**PLANNING APPROVAL &  
PLANNED UNIT DEVELOPMENT  
STAFF REPORT**

**Date: July 21, 2005**

McGill-Toolen High School

# SITE PLAN

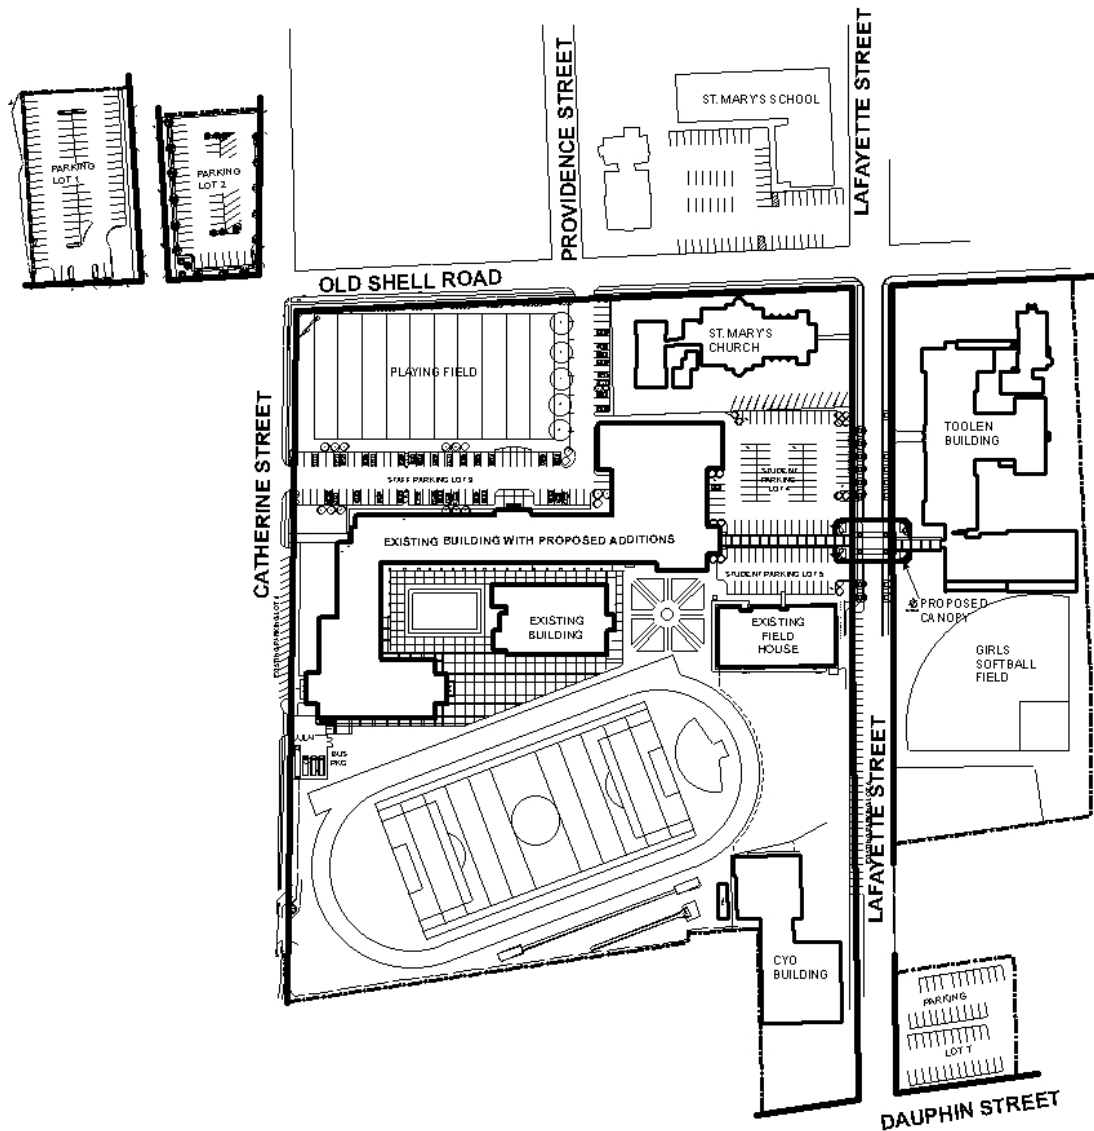
Driveway number, size, location, and design to be approved by Traffic Engineering and conform to AASHTO standards. Standard aisle widths for two-way traffic are twenty-four feet. Adjustments should be made to accommodate the minimum standards for all areas of two-way traffic. A covered pedestrian crossing shall not be built on City right-of-way.

Due to existing 41" Live Oak Tree on right of way, installation of covered walkway over Lafayette Street requires removal of tree. A tree removal permit from the Mobile Tree Commission is required.

The proposed canopy over North Lafayette Street is of concern in terms of compatibility with the neighborhood, architectural design, impact to an existing live oak, and potential impact to use of the street by emergency and non-emergency vehicles. No information has been provided regarding the height or design of the proposed canopy, and there are no similar examples of canopies crossing public rights-of-way in Mobile. Thus, there is no local precedent for the proposal. Pedestrian skybridges are utilized in downtown Mobile on a limited basis between

The site plan does not indicate the location of a stormwater detention basin, which may be required for the site due to the new construction. A stormwater detention basin, sized to meet the requirements of the City's Storm Water Drainage Ordinance, must be indicated on the site plan if it is required. It should also be noted that street flooding has been known to occur in the area, and the presence of large areas of parking lots and buildings significantly contribute to short-term flooding due to stormwater runoff.

Finally, there is no indication on the site plan as to the proposed location of any dumpster or other waste storage facility. If the applicant utilizes a dumpster, the location of the storage area for the dumpster must be indicated on the site plan, and the location and required screening must comply Section IV.D.9. of the Zoning Ordinance, as well as with all other applicable regulations.

Approval of 1) new music / cafeteria area; 2) new fitness center; 3) new courtyard / landscape areas; and 4) rearrangement of on-site parking; subject to the following conditions: 1) depiction of a stormwater detention basin, if required, and; 2) location of any dumpster storage area on the site, and;

Denial of 1) pedestrian crosswalk canopy over North Lafayette Street, per the comments from Traffic Engineering and the concerns regarding precedence, emergency vehicle access, and neighborhood compatibility.
